COPIES	DATE	PAGES	DESCRIPTION
3		1 of 1	OSDS plan for Lot 2 (updated per Health Comments)

MEMORANDUM

RE: Orchard Estates, Lot 2
12407 All Daughters Lane
Highland, MD 20777
"OSDS Comments"

ORCHARD ESTATES
LOT-2 (12407 All Daughters Lane)
LPD Trench Layout Exhibit for a 5-Bedroom House

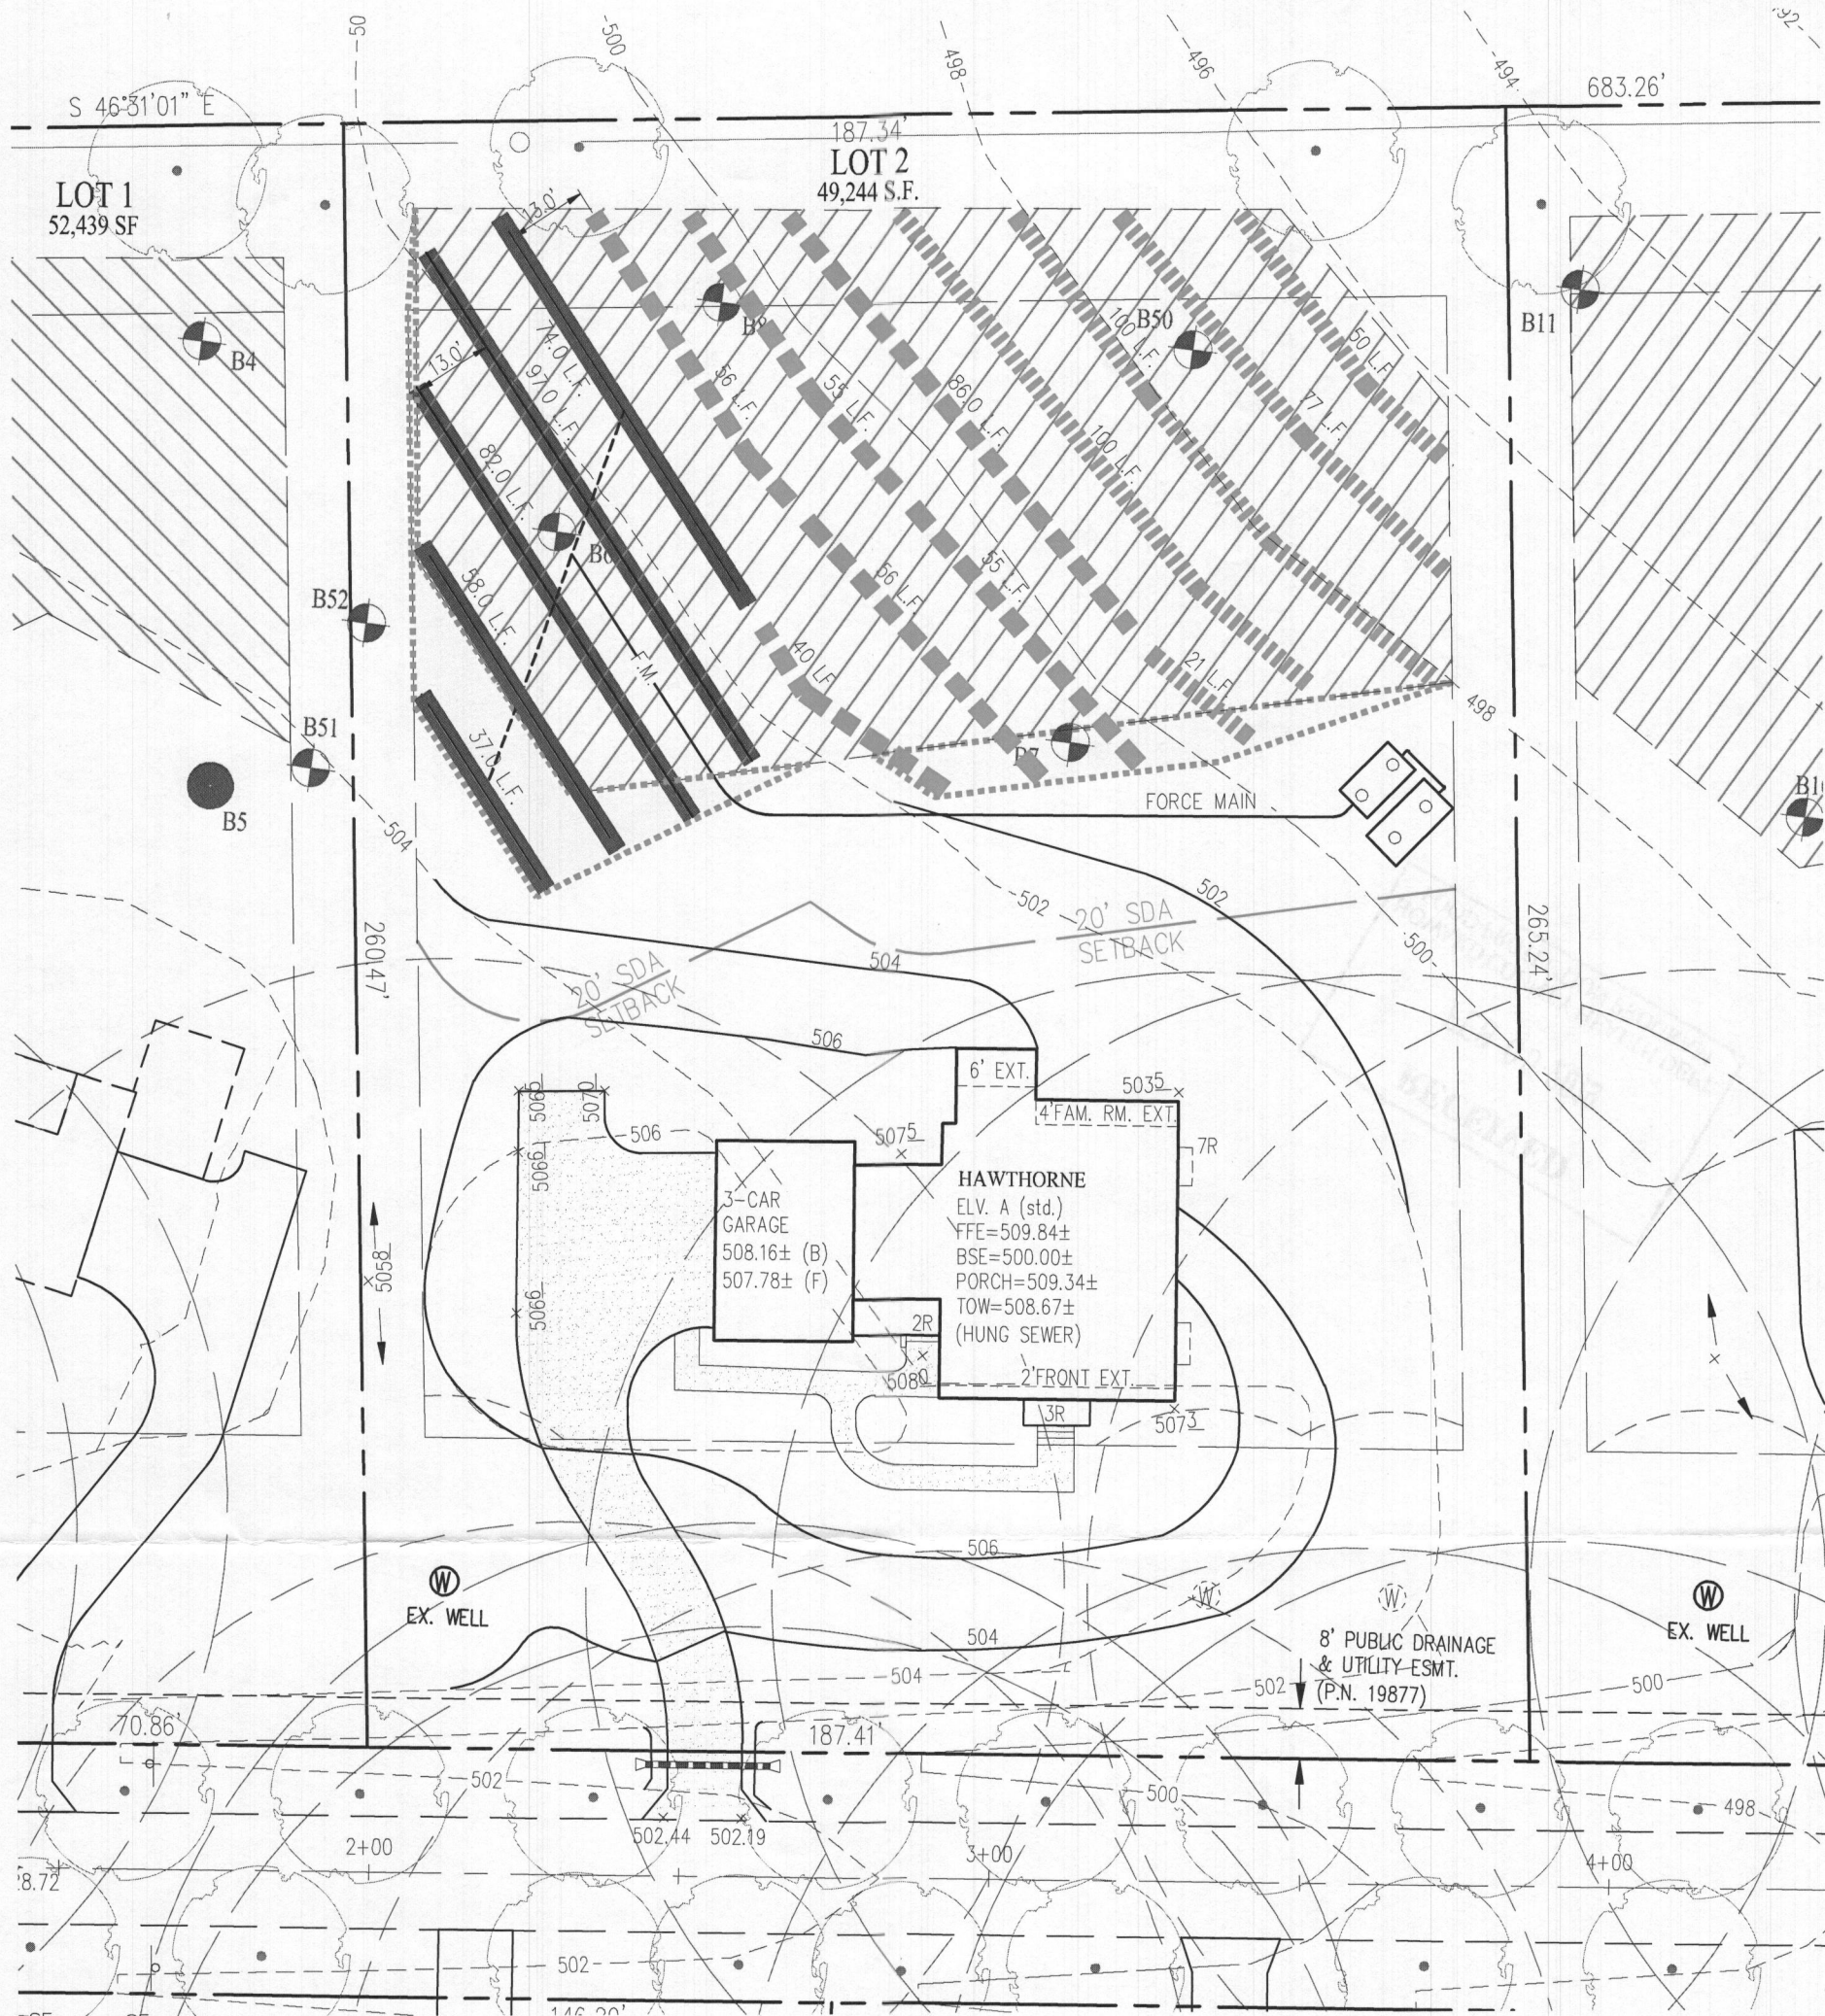
- The perforated holes in the laterals should be 5/16ths. The 1/4th perforations have a higher risk of clogging. Changed hole size to 5/16". Updated distal head to 2' & tweaked trench lengths a tad keep the flow per linear feet of trench well below a ratio of 1.10 (10% difference) for all the trenches.

- In the calculations two laterals are being counted as one. With a center feed manifold its considered two laterals one on either side of the manifold. Acknowledged, please see response below

- All lateral diameters should be the same. This design may be a bit complex for the contractor so we would like to keep it as simple as possible. Noted, made all laterals 1.5" diameter as the number of holes have all been reduced for using the larger 5/16" diameter

- Force main should go around the SDA and not through it. We don't want to disturb the future replacement area. Updated the force main to go around the future replacement area. The force main now connects to the manifold between Trench Nos. 3 & 4.

The spreadsheet calculations account for both center and end-feed lateral configurations to produce the system or Network Discharge Rate (NDR). Since the NDR is based on the number of holes (either 1/4" or 5/16"), the laterals on each side of the center-feed manifold would have half the number of holes, distributing effluent to half the trench length. As a result, the same GPM is produced by two center-feed laterals or an end-feed lateral when the total number of holes are the same for both lateral configurations for a particular trench. Though the trench length is the same for both end-feed and center-feed configurations (with the same number of sized holes), it may be possible to use a smaller pipe diameter for each half of the center-feed lateral when an end-feed lateral needs a larger pipe.

Also, added this note: "Electrical work for the installation must be preformed by a licensed electrician" per your email.
